Invitation for Bids Number: 14-20

Addendum 1

**RHODE ISLAND PUBLIC TRANSIT AUTHORITY**  
**Request for Proposal Number 14-20**  
**REVISED TECHNICAL SPECIFICATIONS/SCOPE OF WORK**

**REVISED DRAWING OF 16/4 VAN**

16688 WALL STREET  
TITLE: FLOOR STEEL ASM, AIF24  
STANDARD FLOOR

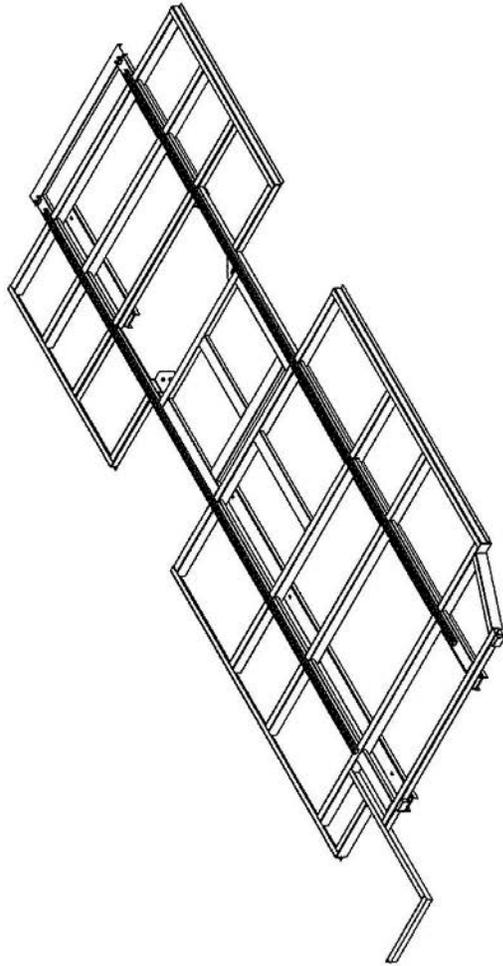
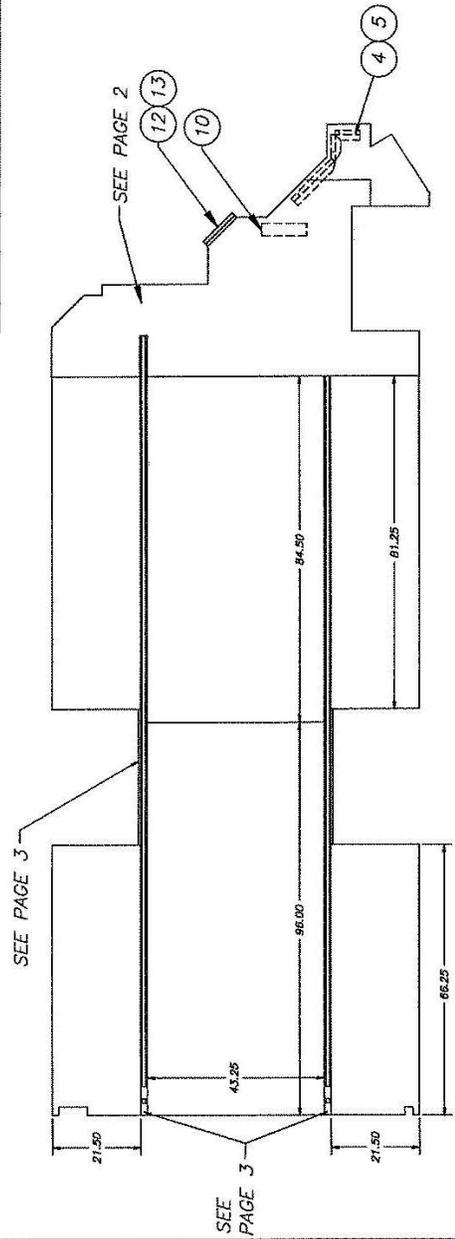
The floor structure shall be computer load tested to withstand 40,000 pounds with less than 1/16" of deflection at the perimeter. All surface irregularities shall be filled and subfloor sanded smoothly.

Subfloor shall be exterior .75", 7-ply, marine-grade plywood with a solid cross band that is pattern cut, edge sealed, and fastened with #10 gauge counter sunk Tek screws installed approximately every 10" throughout the entire floor structure.

We do not use an underbelly-pan as it is not needed for strength and only traps moisture thus corroding the floor. With our design, the floor is warranted for seven (7) years. See attached drawing of floor frame.

Accepted: X Rejected: See Addendum #

**TITLE:**  
 PILLAR ASM, AT (UNIT/OPTION)  
 NEW BODY WALL CONSTRUCTION

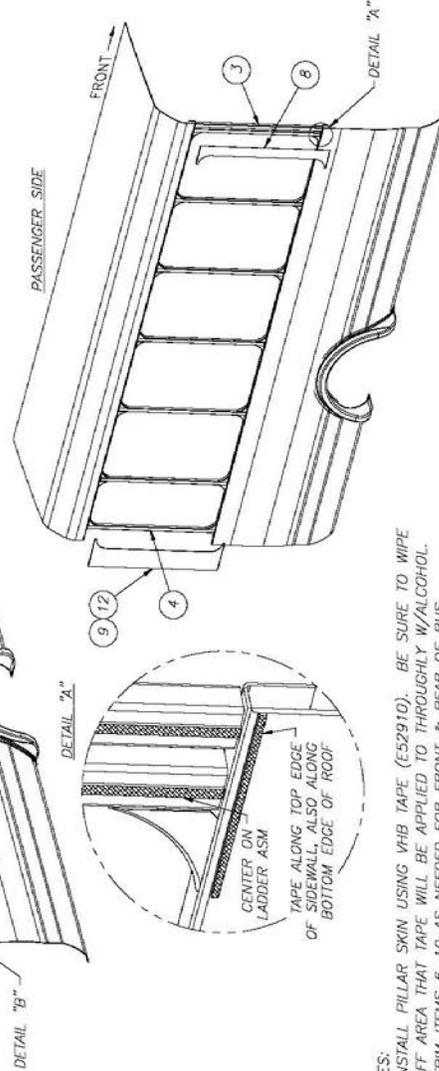
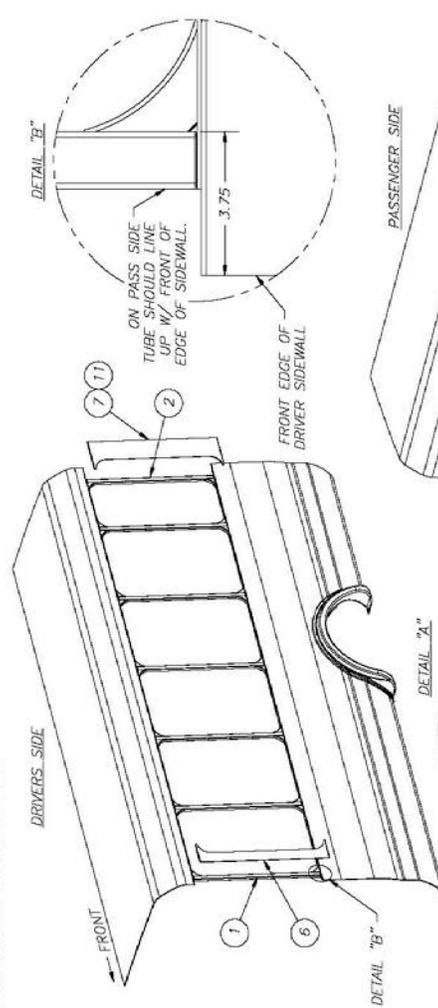
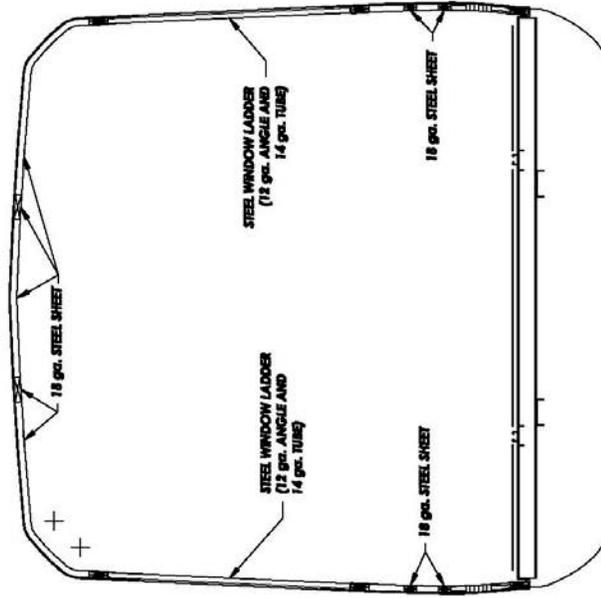
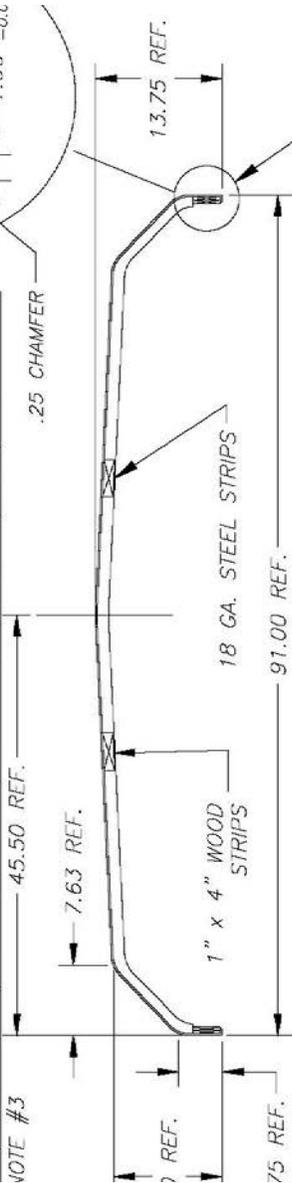
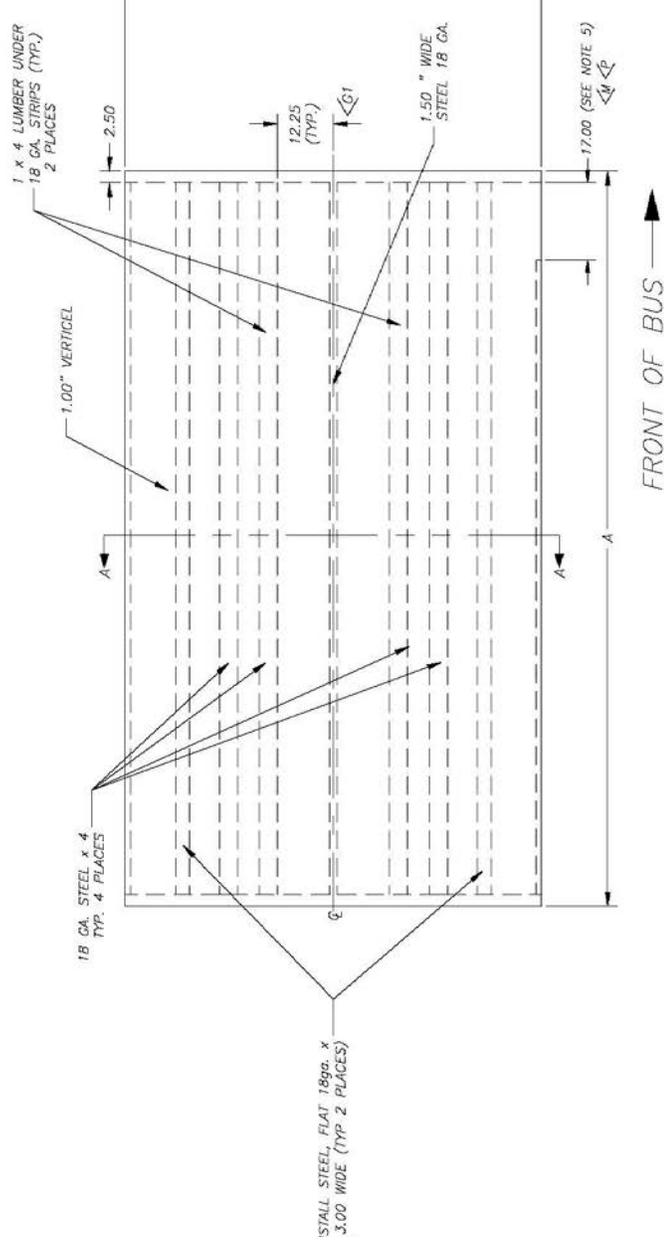
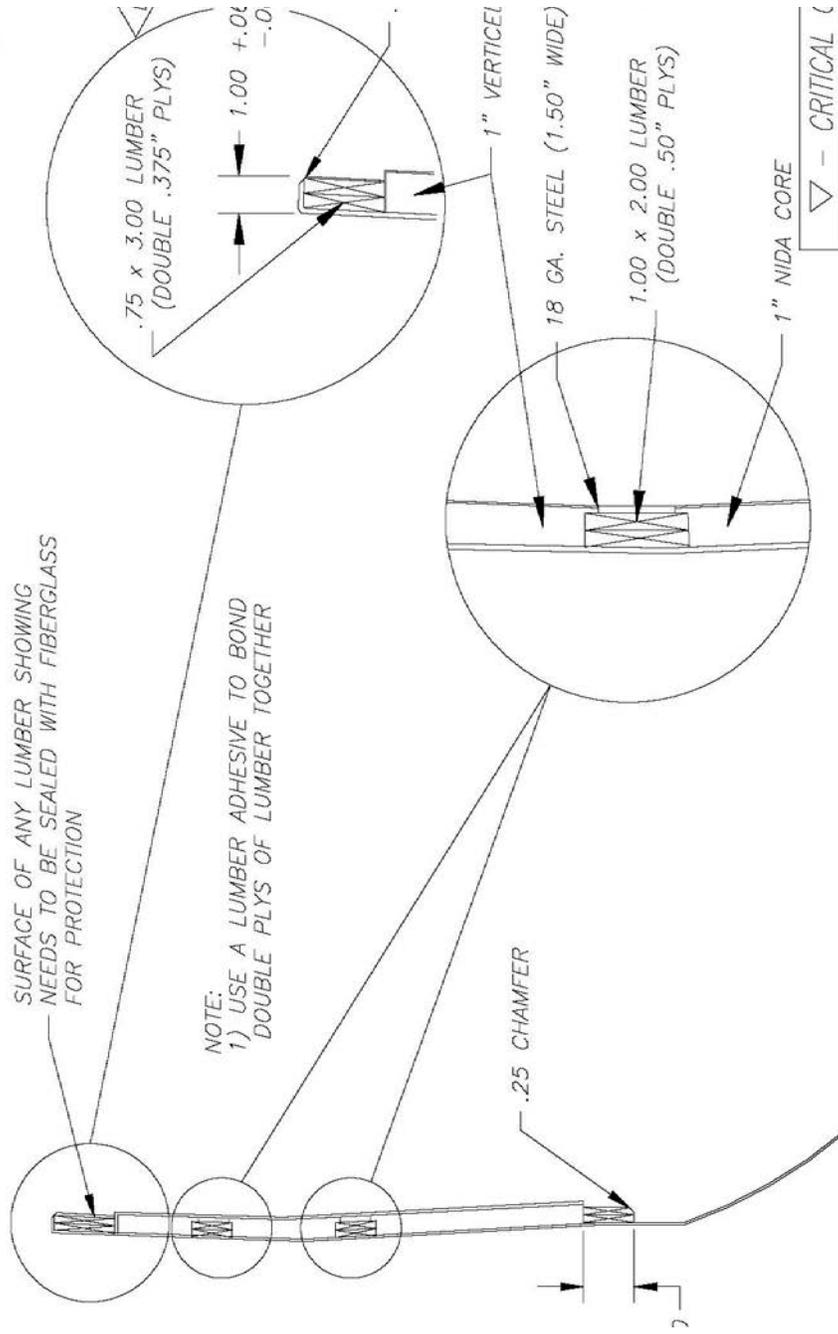
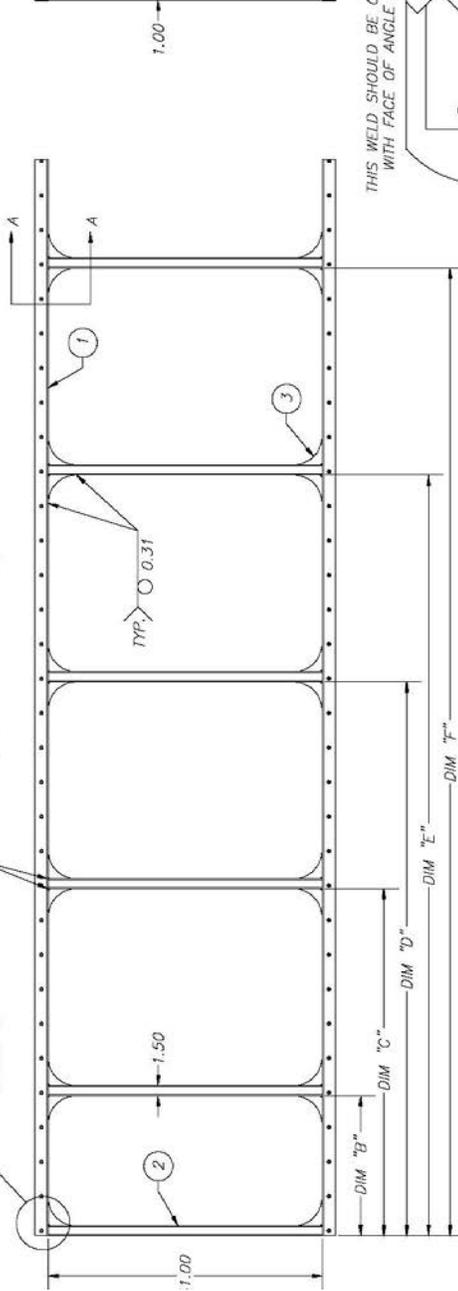
We request approval of the attached corrosion-free body structure. We meet all application commercial FMVSS as well as school bus FMVSS for joint strength and rollover. This is also the only vehicle of its class to be successfully crash tested and is built by the No. 1 manufacturer of its type.

Drawings also attached.
